Re: Oconee Nuclear Station  
Docket Nos. 50-269, -270, -287

RESPONSE TO NRC REQUEST FOR  
ADDITIONAL INFORMATION  
FOR  
MEASURES TO PROTECT AGAINST REACTOR VESSEL OVERPRESSURIZATION

## REVISED EVALUATION OF POTENTIAL REACTOR VESSEL OVERPRESSURIZATION

FIGURE A-1  
PRESSURE TRANSIENT FOR ACTUATION OF ONE HPI TRAIN

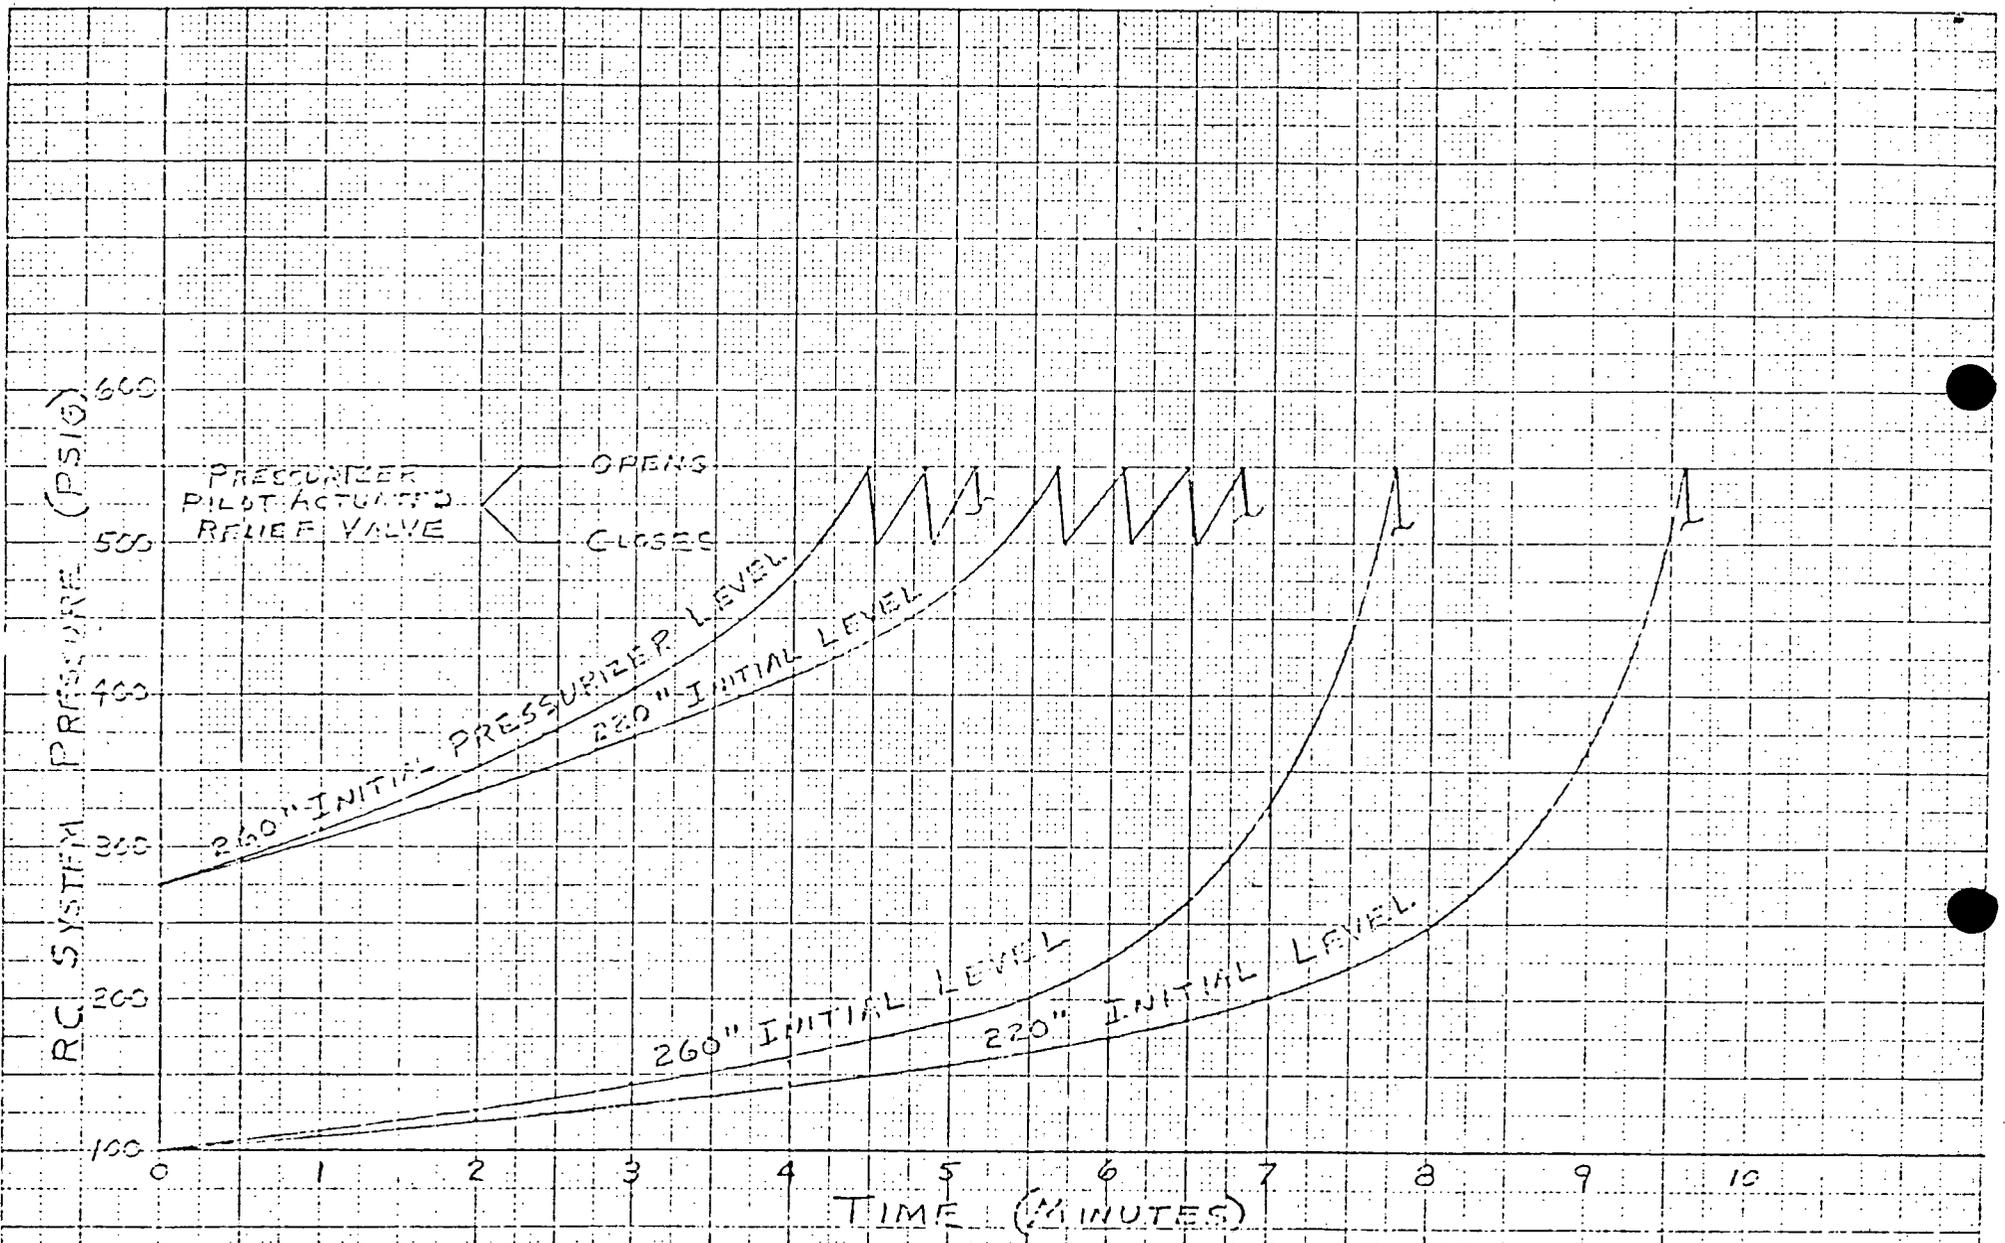
Please provide a transient analysis of the reactor coolant system response to inadvertent actuation of a single train of high pressure injection pumps. Describe what administrative controls and procedures are used during startup and shutdown, and during component and/or system testing to justify the assumption that inadvertent injection by more than one high pressure train is not credible. Provide a similar discussion and analysis of a core flood tank discharge. For both situations indicate the basis for identifying the limiting single failure or common failure mode.

Figure A-1, attached, presents the analysis requested. The pressure response of the RCS for actuation of one HPI train is shown for initial pressurizer water levels at the hi level alarm (260") and at normal level (220") for initial pressures of 275 psig and 100 psig. Letdown flow was not used in the calculation. The pilot actuated relief valve has a steam (or nitrogen) relief capacity greater than the injection rate of two HPI trains and a liquid relief capacity equal to or greater than the injection rate of one HPI train. This event is considered not credible because the circuit breakers for the normally closed HP injection motor operated valves are "racked out" during the plant cooldown prior to startup of the Decay Heat Removal System. The breakers would not be "racked in" during plant heatup until RCS temperature reaches 250°F.

FIGURE 1

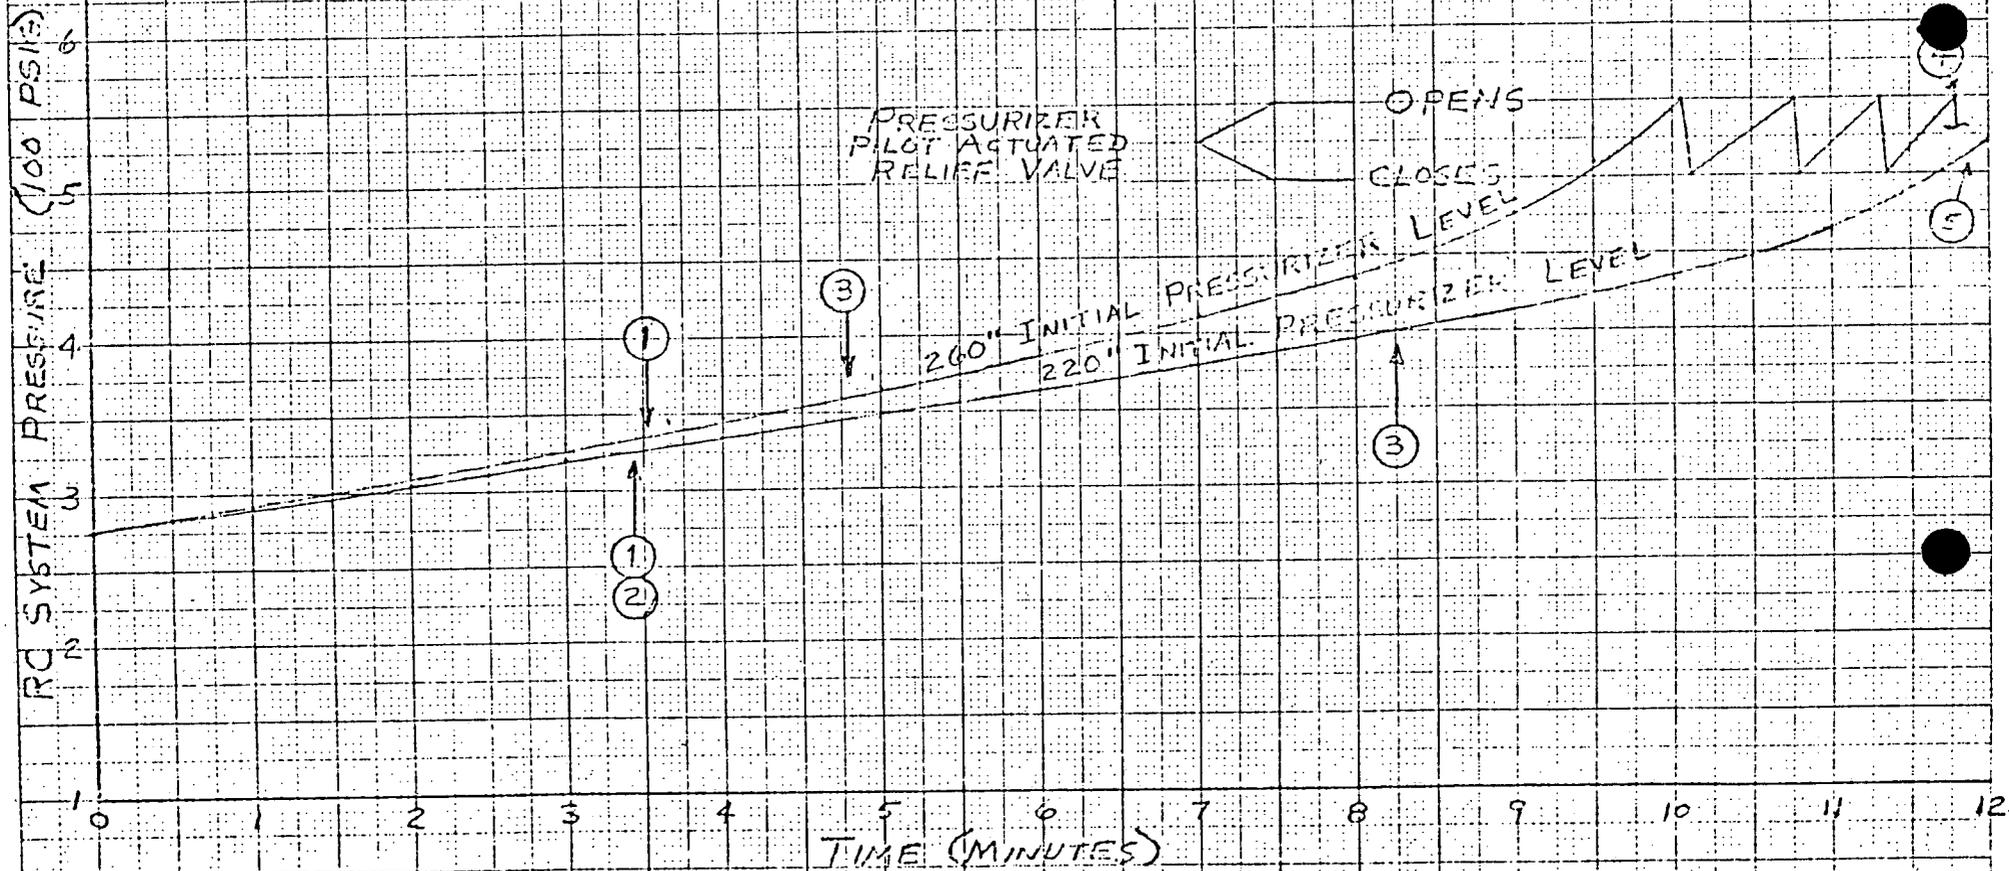
Provide a failure modes and effects analysis of the overpressure protection system for startup, shutdown, and testing operations which defines the limiting combination of initiating event and additional single failure or operator error subsequent to initiation of the overpressure transient.

This valve is HP-120 on FSAR Figure 9-2 and is automatically controlled by the pressurizer level controller. The pressure response of the RCS to this event is shown on Figures 1 and 1A. If it is assumed that the operator does not take action to terminate the event during the pressure increase, the peak RCS pressure is limited to 550 PSIG by the pressurizer pilot actuated relief valve. Initial conditions used for the analysis were:

Figure 1 is for an initial RCS pressure of 275 PSIG. This is the RCS pressure at which the Decay Heat Removal System is Started up during plant cooldown or at which the RC pumps are started during plant heatup. Figure 1 depicts two pressure response curves. One pressure response curve is for the initial pressurizer water level at the high

alarm setpoint (260") and the other pressure response curve is for the initial level at the normal level (220"). At this pressure (275 PSIG) during the startup or shutdown operation, the level would normally be below the normal level of 220" which would result in emptying of the makeup tank and termination of the transient at a pressure much lower than 550 PSIG.
